ACCESSORIES DO NOT POWER UP FROM THE FRONT 12 V POWER SOCKET PLUG

This Service Information Bulletin (Revision 4) replaces SI B61 01 20 **dated March 2021.**

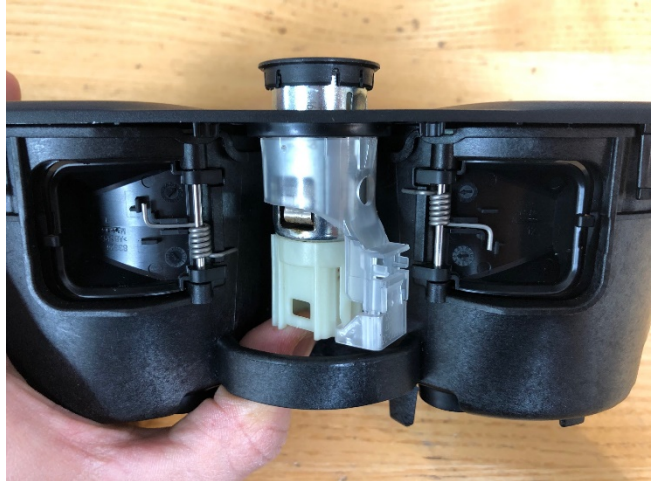
A design change was intended to reduce short circuits and blown fuses. When the plug adapter is inserted, the center contact pin may not make proper contact with the center pin of the power socket plug.

- Replace the plug-in socket (new design and repair procedure)

**IMPORTANT:** The procedure to install this newly designed component will remove the functionality of the cigarette lighter and the ambient ring lighting if equipped.
